CITY OF ALBUQUERQUE

**RE: Mercado El Milagro - Buildings G1 and G2
10000 Central Ave SW
30-day Temporary Certificate of Occupancy
Engineer's Certification Date: 10/31/25
Engineer's Stamp Date: 03/28/2024
Hydrology File: L09D042B
Case # HYDR-2025-00394**

G1 GRADING & DRAINAGE PLAN

G2 GRADING & DRAINAGE PLAN

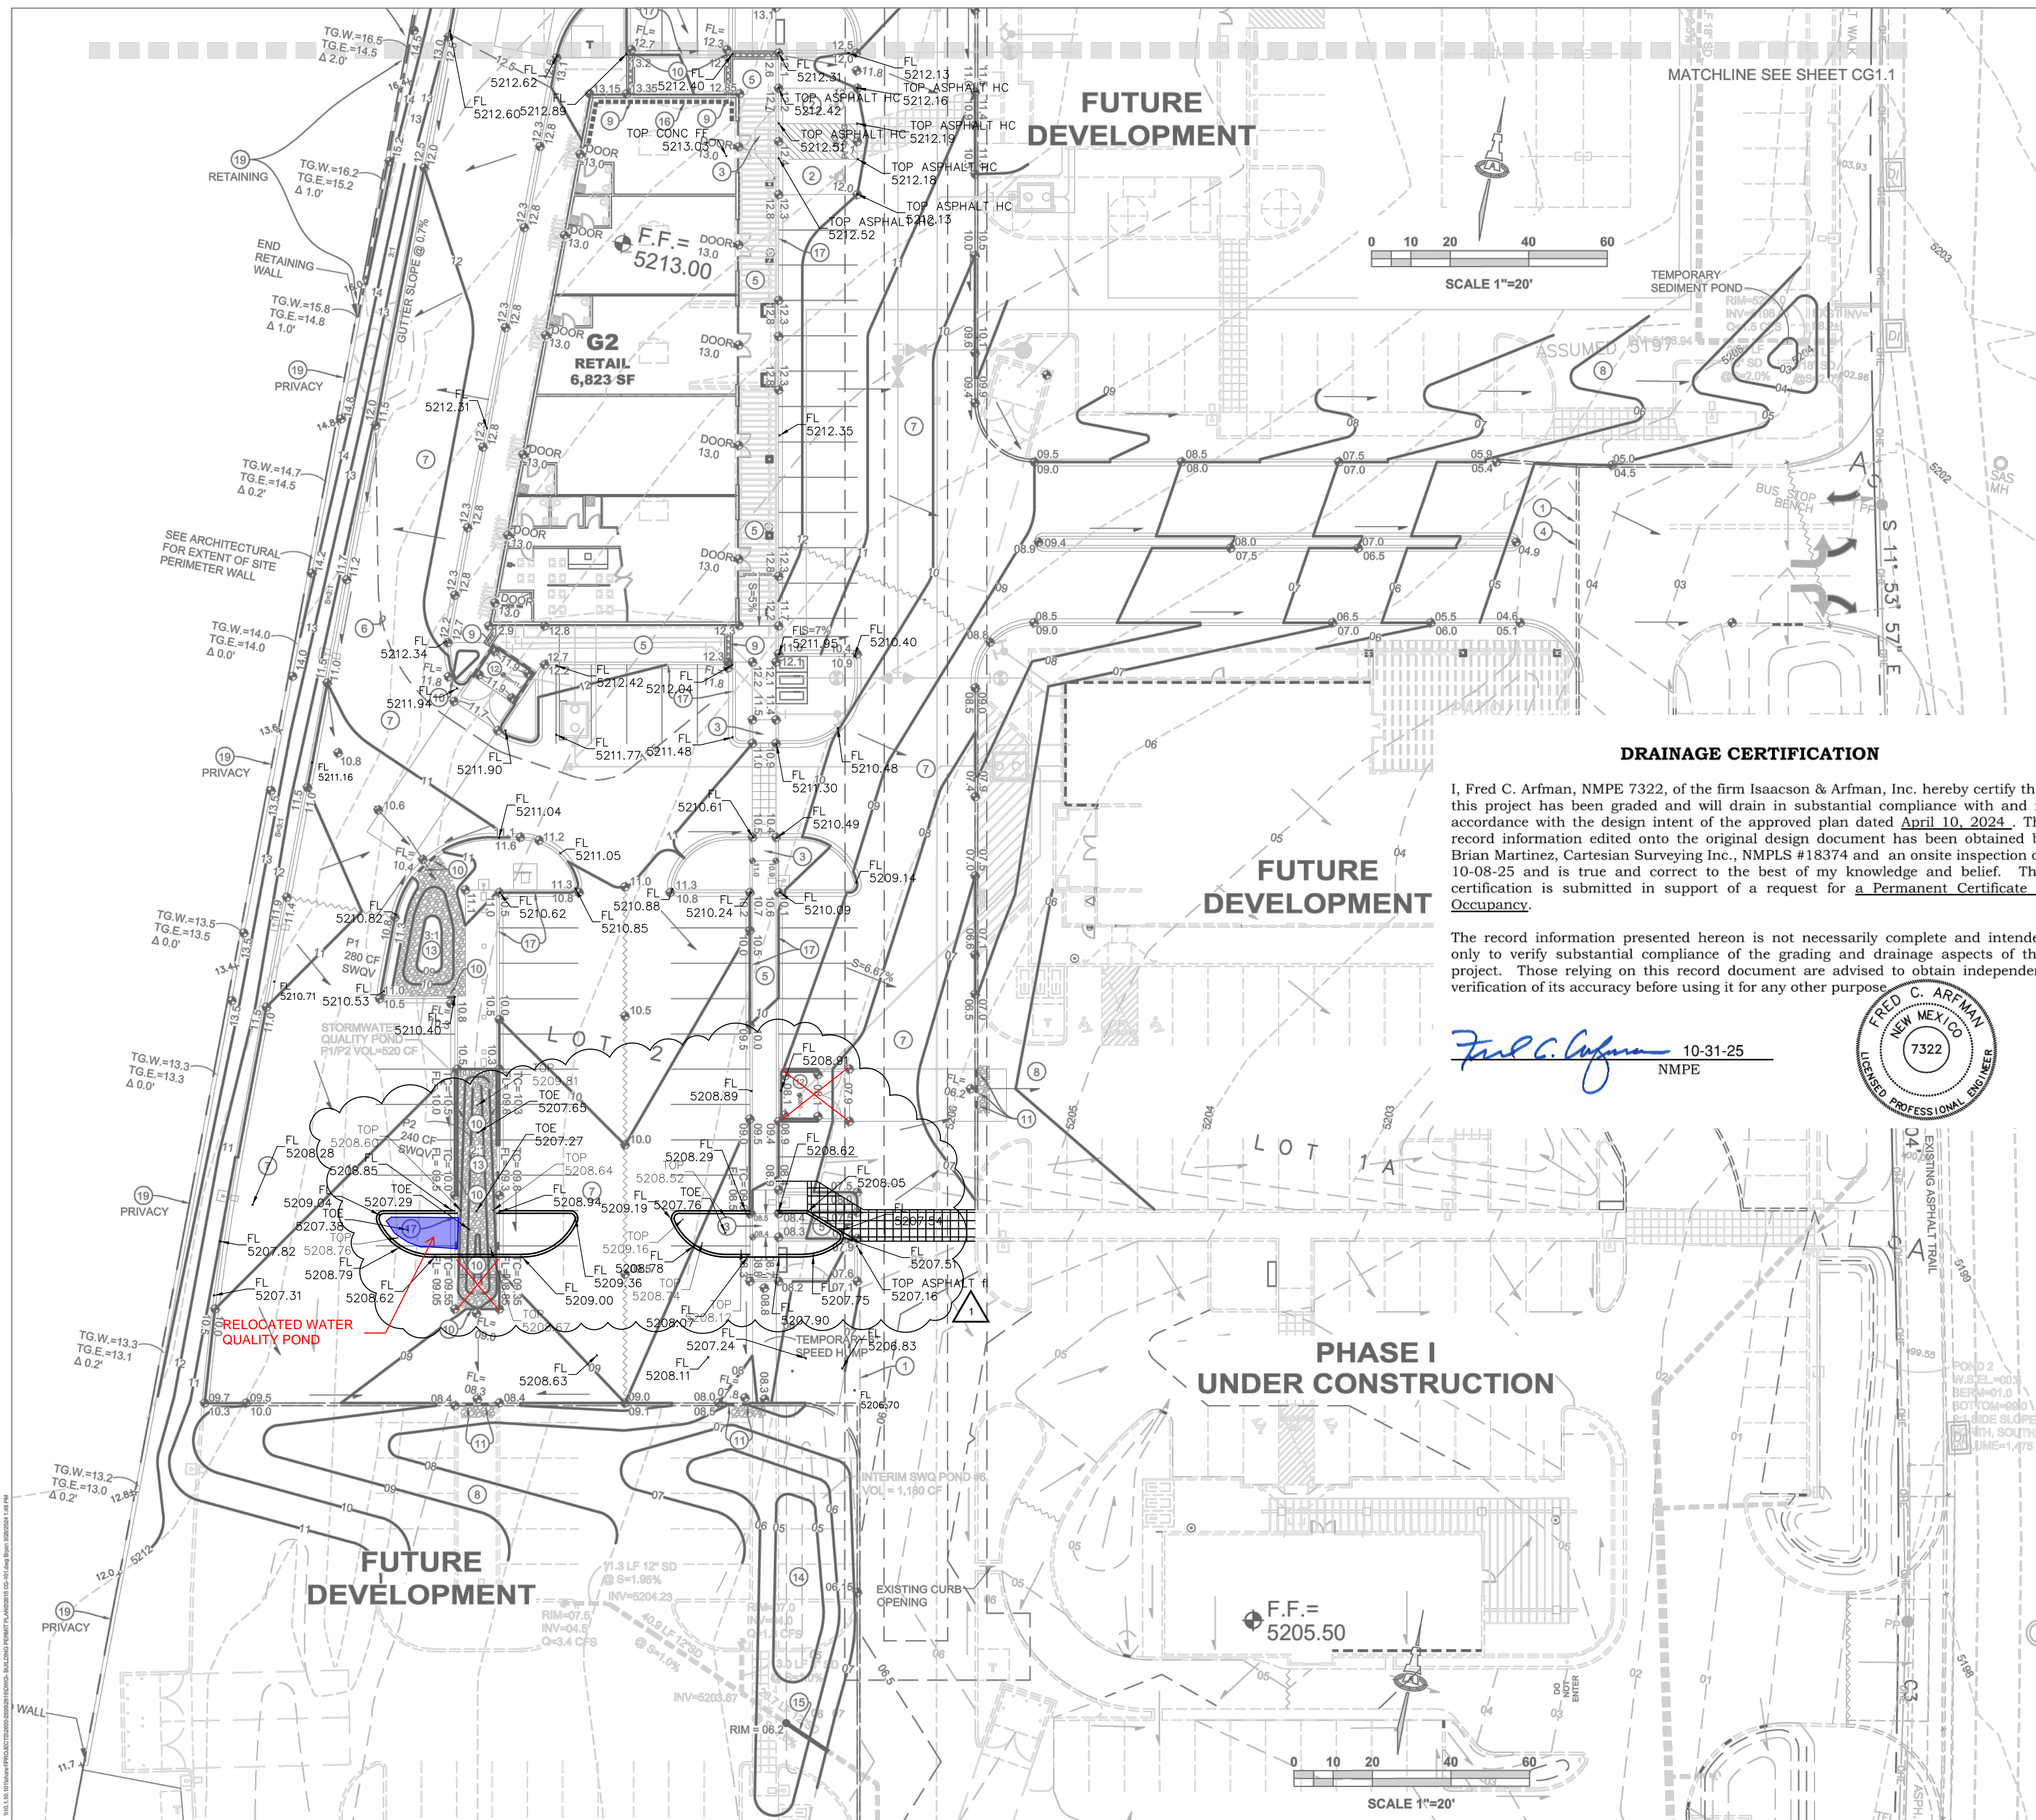
SITE PLAN REVISION

SITE PLAN REVISION DURING CONSTRUCTION FOR PARKING ISLANDS & REFUSE ENCLOSURE WITH CITY OF ALBUQUERQUE APPROVAL.

PER REQUEST, SITE PLAN REVISIONS SHOWN ON FINAL GRADING & DRAINAGE CERTIFICATION
